Access Compliance Report

Public Rights-of-Way

(Curb Ramps)

Intersection ID: 7969	Main Street: BROOKSHIRE_BV	Cross Street: N_HOSKINS_RD	Location: NE
ADA ID: E270C7AAA673	Ramp Type: Para	Initial Pass/Fail: Fail	Overall Compliance: No
		Severity Score: 25

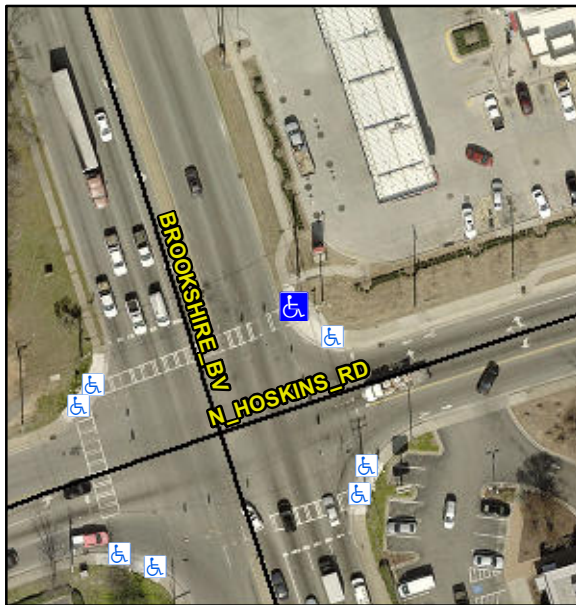
Surveyor Notes:

RT RP < 5%

PROW/ADA:

R304.3.2

Possible Solutions:

Remove & Replace Entire Ramp.
